PEARL NEIGHBORS FOR INTEGRITY IN DESIGN APPEAL OF HYATT PLACE

Appeal Case # LU 19-145295 DZM

Pearl Neighbors for Integrity in Design

LU 19-145295

Proposal Fails to “Complement the Context of Existing Buildings” – C4

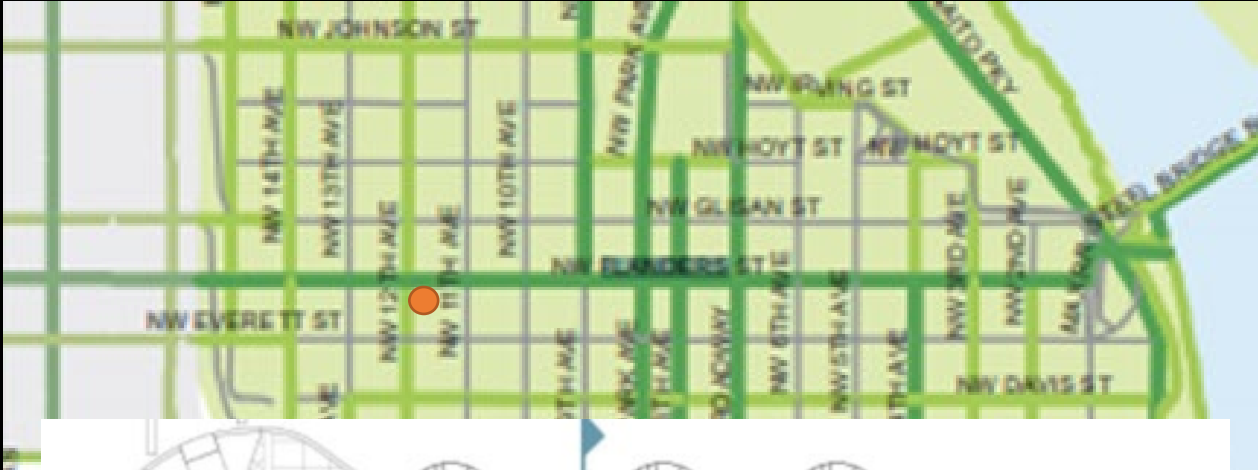
The Design Commission found the use of concrete paneling and setting the base 2' proud of the upper stories at the historic building datum satisfied this standard.

- The Hyatt will stand 19 stories taller than adjacent historic resources. Improvements to the building's base does nothing to mitigate or otherwise complement the shadow that this glass box will cast on the district.
- Concrete paneling and historic building datum line will not be visible from the historic district.
- No punched, multi-pane windows, material texture or variation to simulate brick on the upper stories that would serve to make the building “complementary.”

The Flanders Greenway is not “integrated” into this design – A5

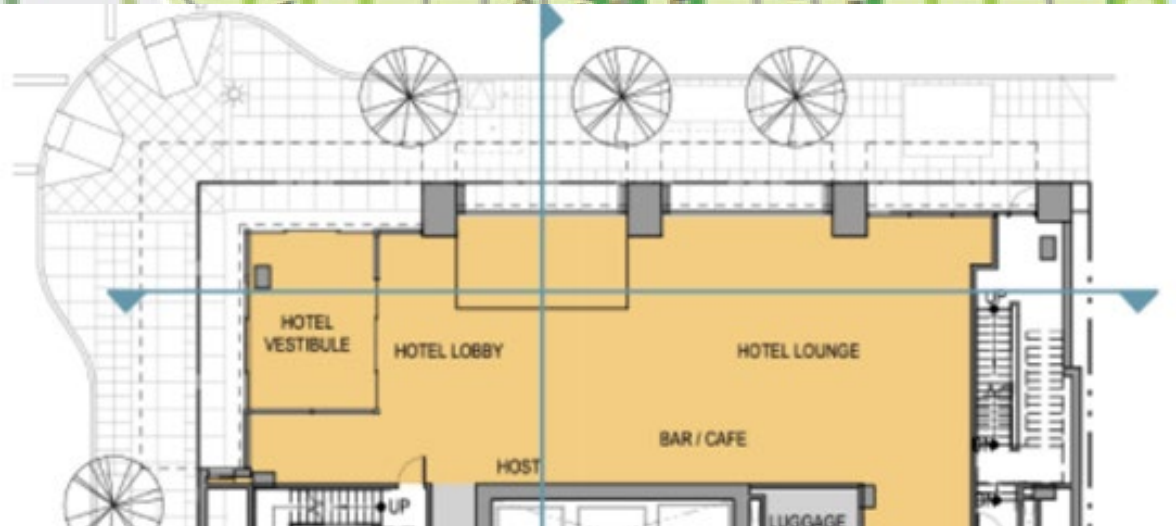
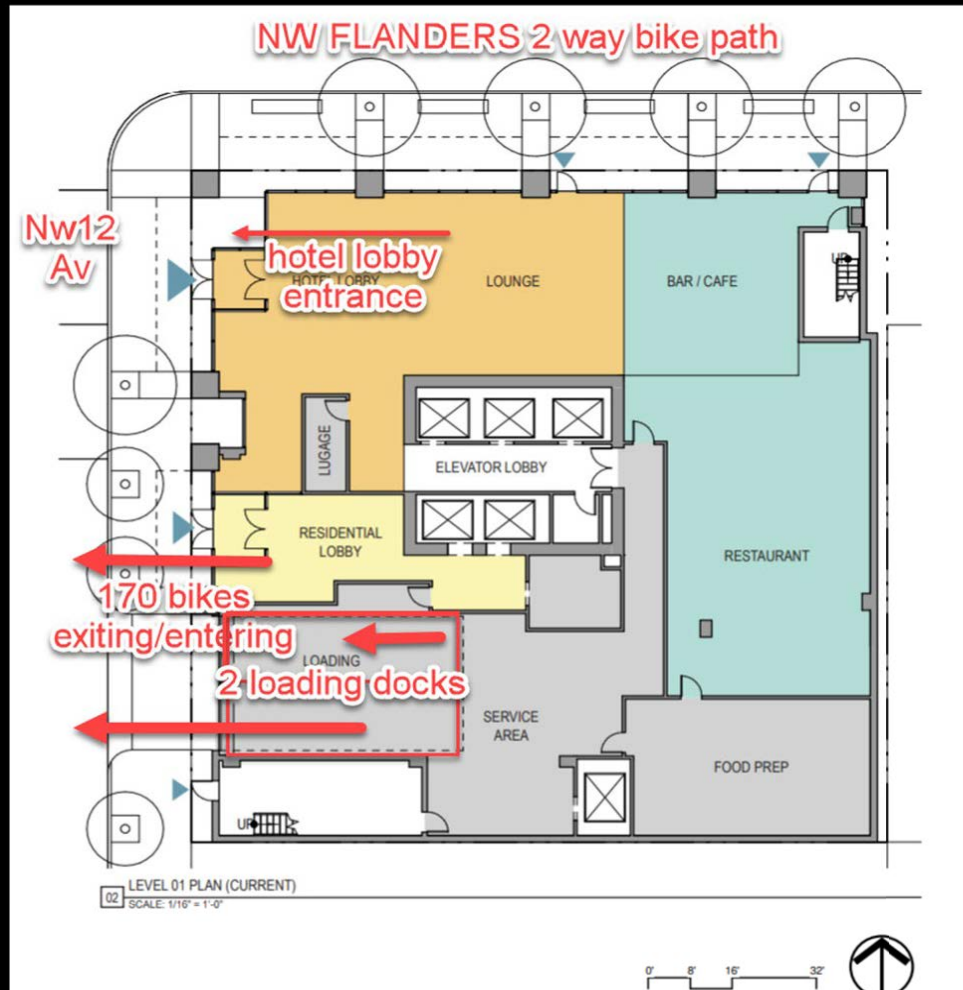
The ONLY engagement with the Greenway identified by the Design Commission is the use of “large operable fully glazed storefront systems and retail area.”

- No ground-floor retail; it is a hotel lobby and café – not retail.
- No off-street, on-site short-term bicycle parking or other public amenities catering to bicyclists.

This design turns its back on the Greenway rather than “enhancing” or “reinforcing it.” Guideline A5

Fails to “Protect the Pedestrian from Vehicle Movement” – B2

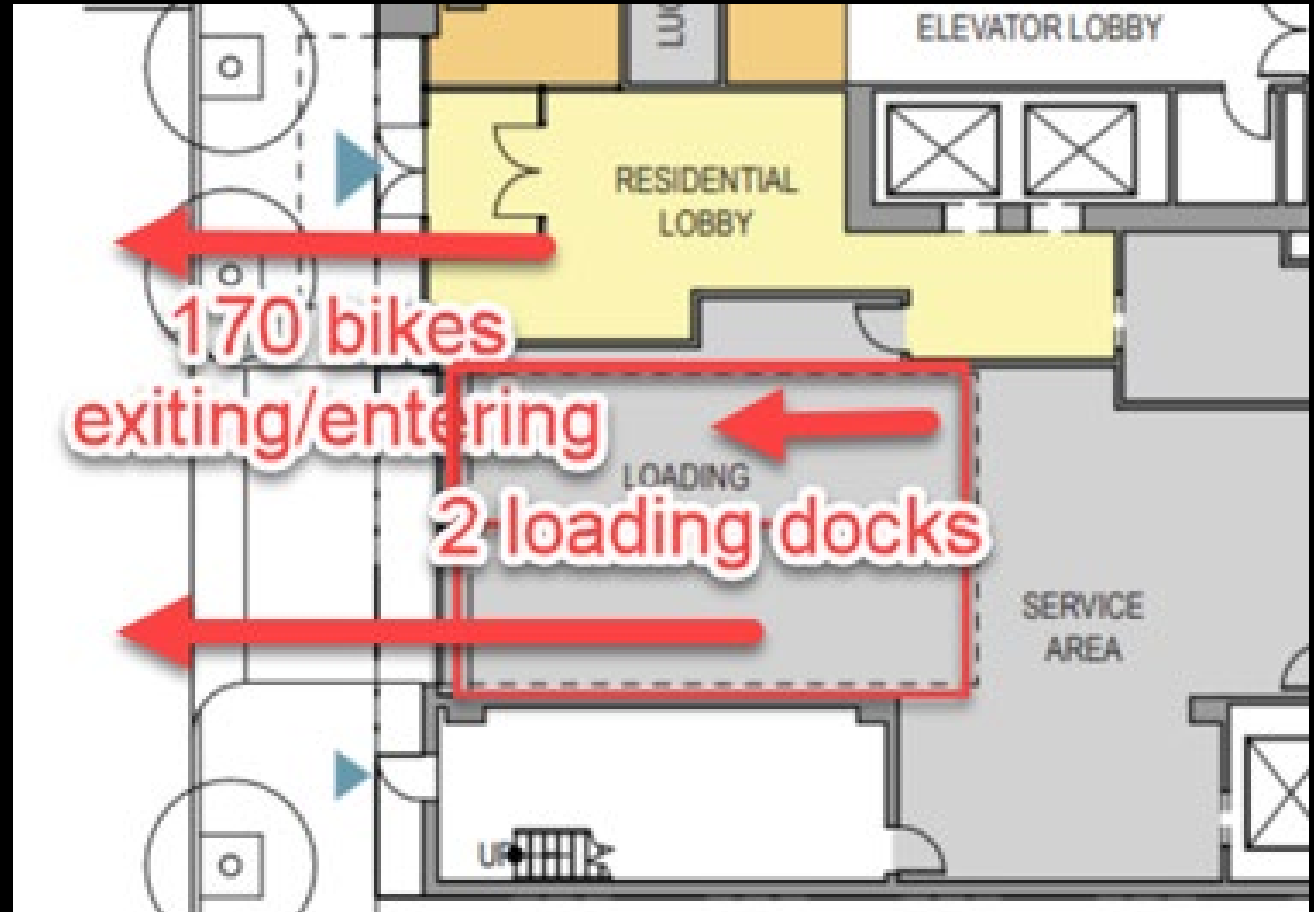
“Building service areas for large vehicle access should also be located where they will not negatively impact the pedestrian environment.”

- The loading area is immediately adjacent to the sole entry to 113 dwelling units and 170 long-term bicycle spaces “negatively impacting the pedestrian environment.”

View looking east with the NW 13th Ave. Historic District in the foreground

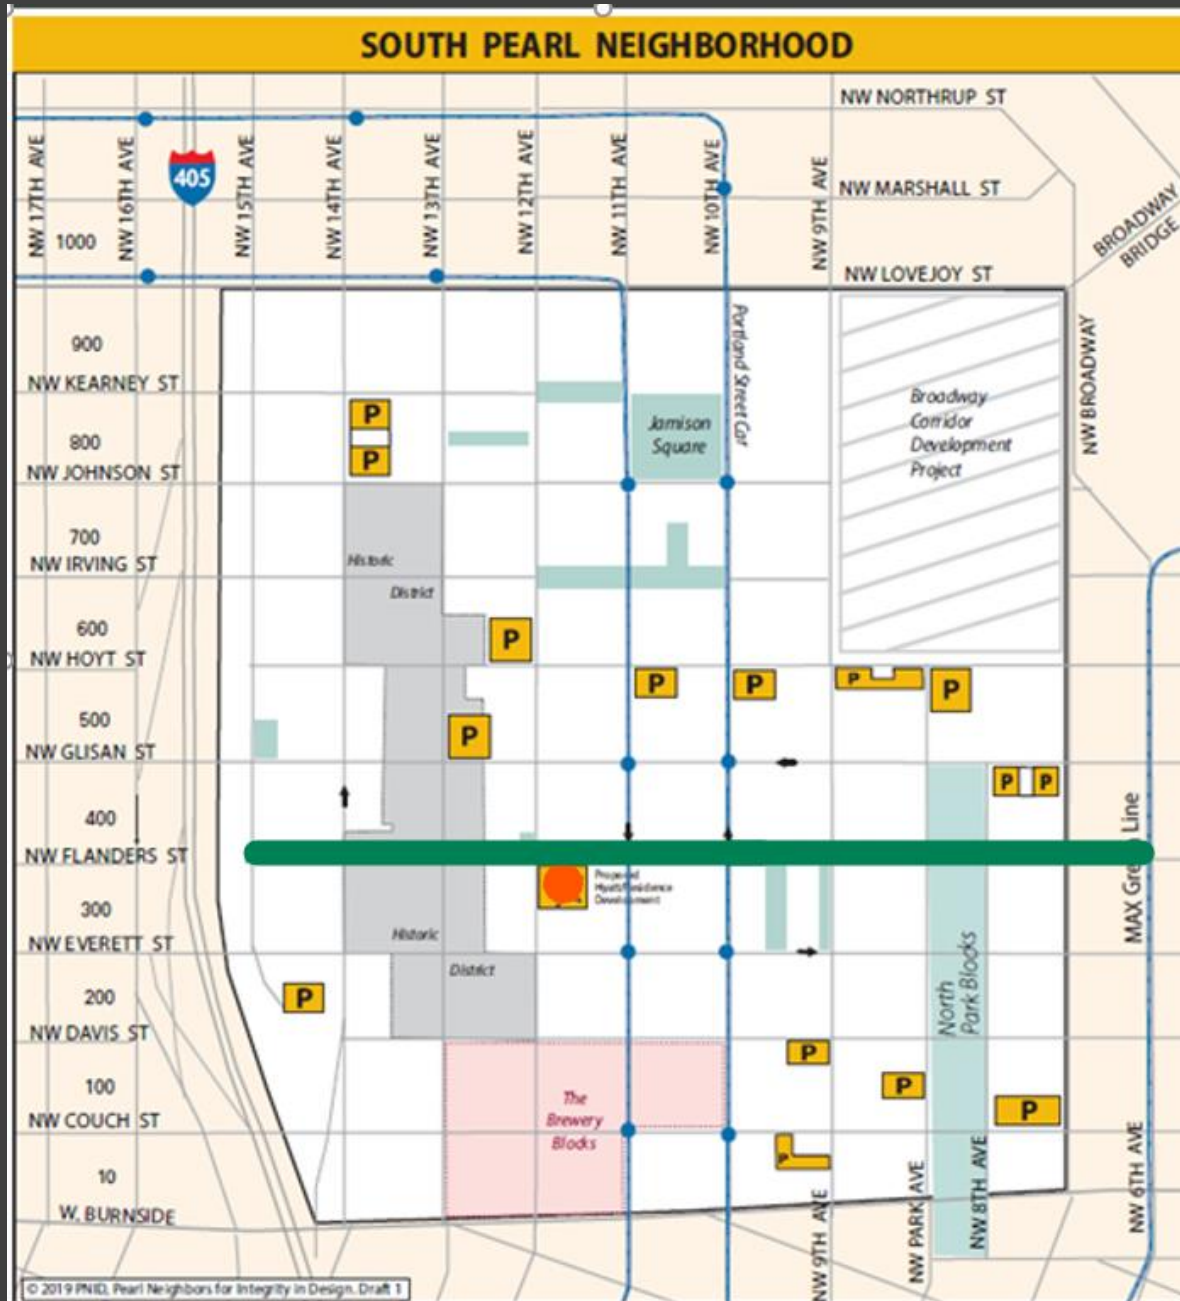
Design must “Enhance” Unique Qualities (A5):

- One half a block from the 13th Ave Historic District - 3-4 story historic masonry warehouse buildings
- Flanders Bikeway from Naito Pkwy to NW 24th over the new I-405 pedestrian and bike bridge
- NW 12th Ave - a 36-foot wide street with metered parking on both sides – before development experiences 1900 vehicles per day

Depth of the middle setback is not reflective of towers near the NW 13th Ave Historic District

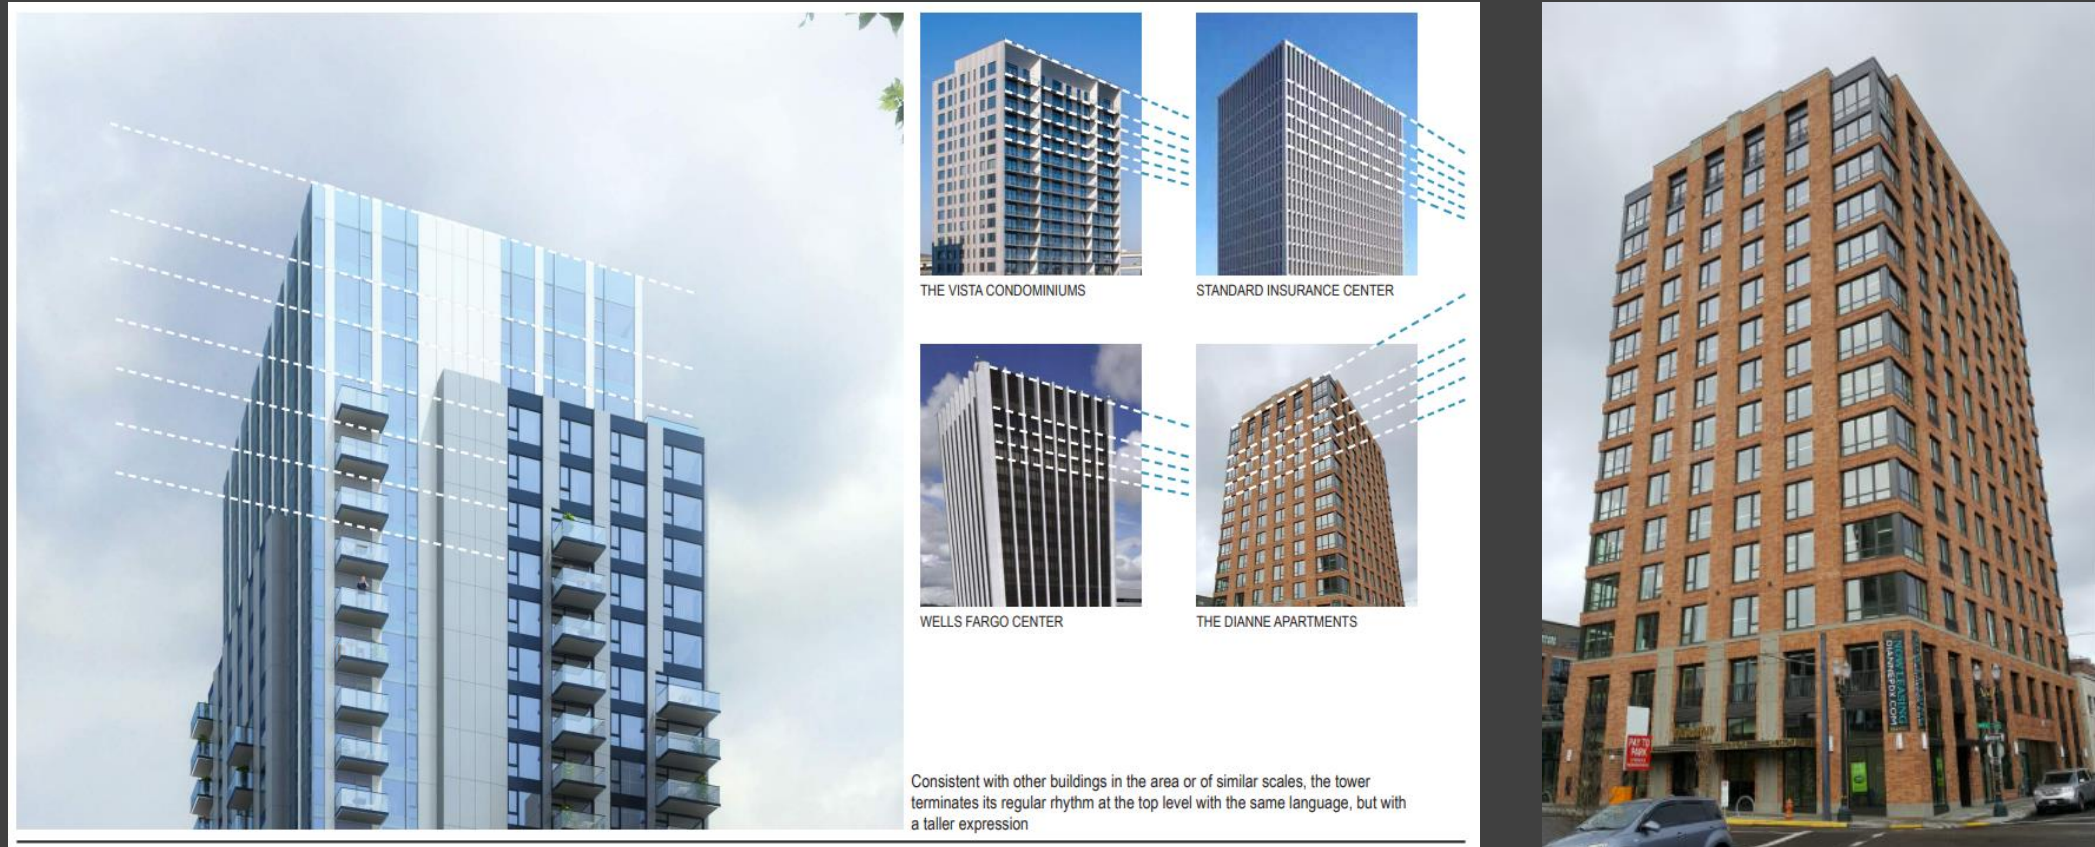
A 3-foot transition from middle to top is not sufficient as evidenced by setbacks on other towers, even those presented by the applicant. Other building setbacks are wide enough to accommodate tables.

Treatment of top of the tower is most visible from the 13th Ave Historic District and entirely out of context

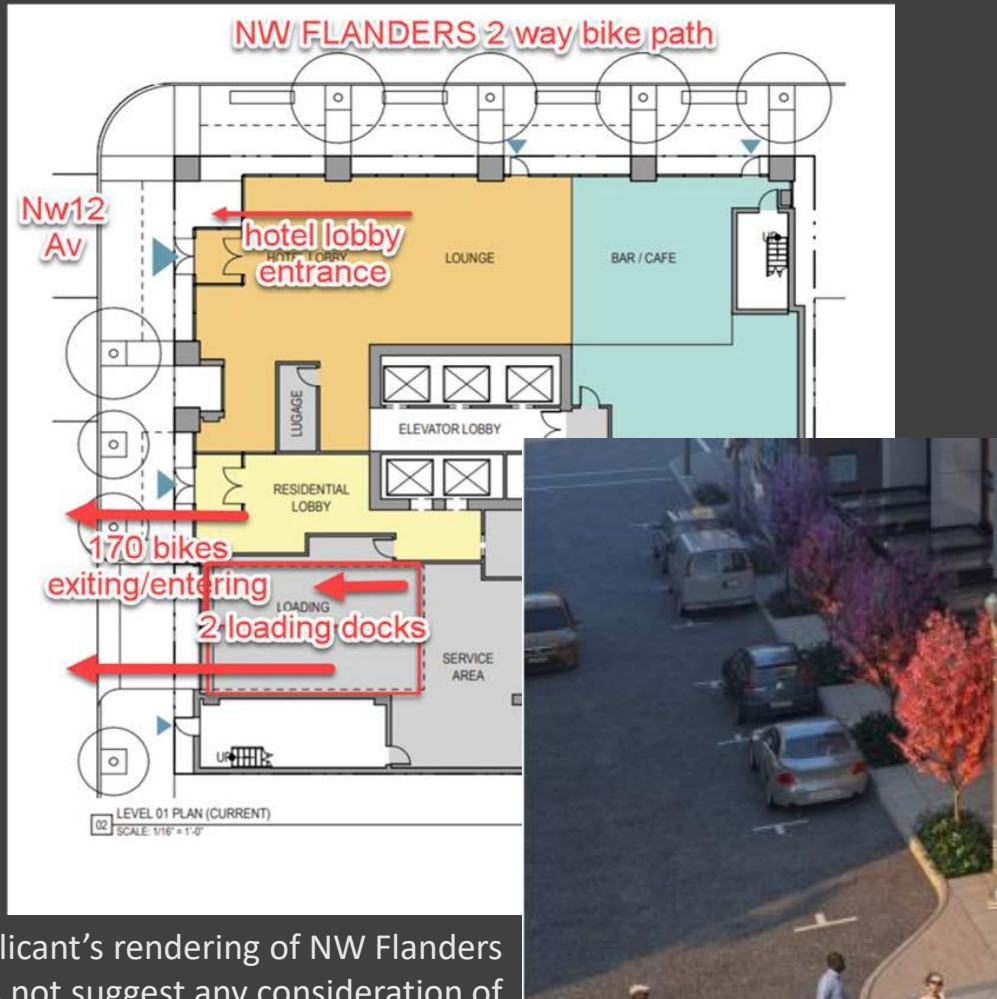
The applicant's top-of-tower context study admits the design mirrors that of buildings outside the district. The Dianne, the only example in the Pearl, depicts a completely distinguishable modern take on art deco, masonry structure with an articulated cap acknowledging the Historic District.

Design fails to integrate the Flanders Bikeway and does not encourage cycling

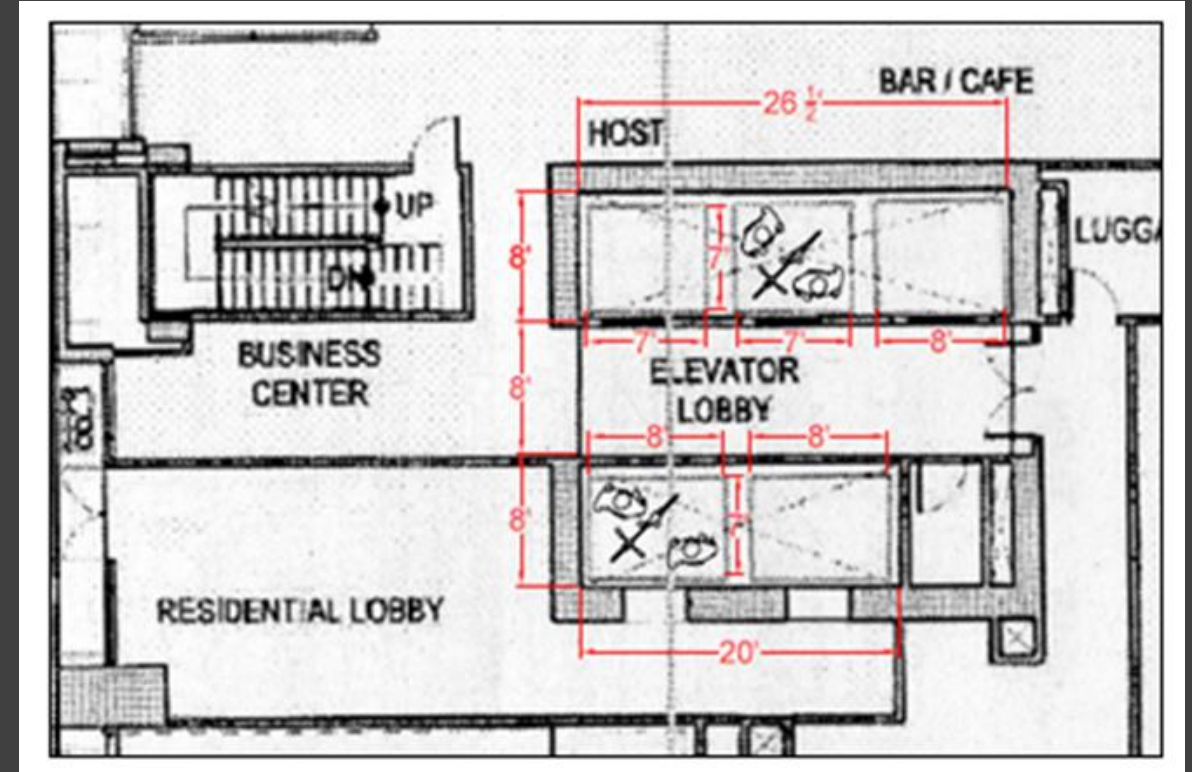
Applicant's rendering of NW Flanders does not suggest any consideration of bicyclists.

No out-of-traffic curb cut along NW 12th to unload, a shared resident and bicycle entrance, elevator-only access to long-term bike parking and no short-term parking – all conditions resulting from this design.
